Our Ref: F2019/00109

Application No: SSD 9606

**RE: Randwick City Council Submission on the State Significant Development
Application: Building D14, University of New South Wales Kensington Campus
(SSD 9606)**

Source: Arup Traffic report pg.11

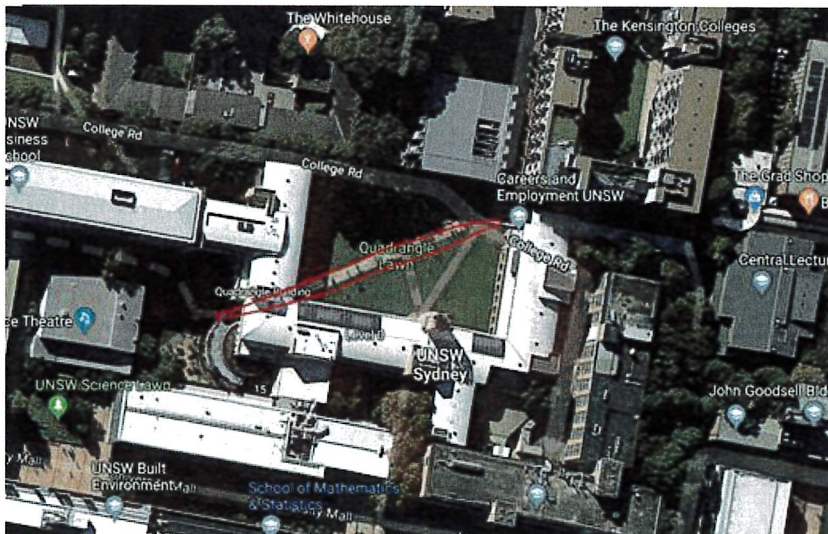
Council notes that the EIS outlines that there are "*several bicycle racks and u-rail facilities are within close proximity to the site*". However, without detailed knowledge of the bicycle parking provision on campus it is difficult for Council to make an informed assessment of bicycle parking supply in relation to Building D14. Similarly, while Council supports the proposed end of trip facilities, further information is required. Such as, are the 45 bicycle parking spaces open to all staff and students? The room specified as bicycle parking is suggestive, but unclear. Moreover, the drawing indicates very tightly packed bicycle parking hoops in the specified room. The Australian Standard states that racks / hoops must be a minimum of 1m apart to enable access. On this basis, Council requests that more detailed information be provided of the planned bicycle parking arrangement.

Council also notes that the diagonal movement through the nearby Quadrangle lawn area is a strong (primary) pedestrian link, and cautionary signage advising of nearby construction is encouraged.
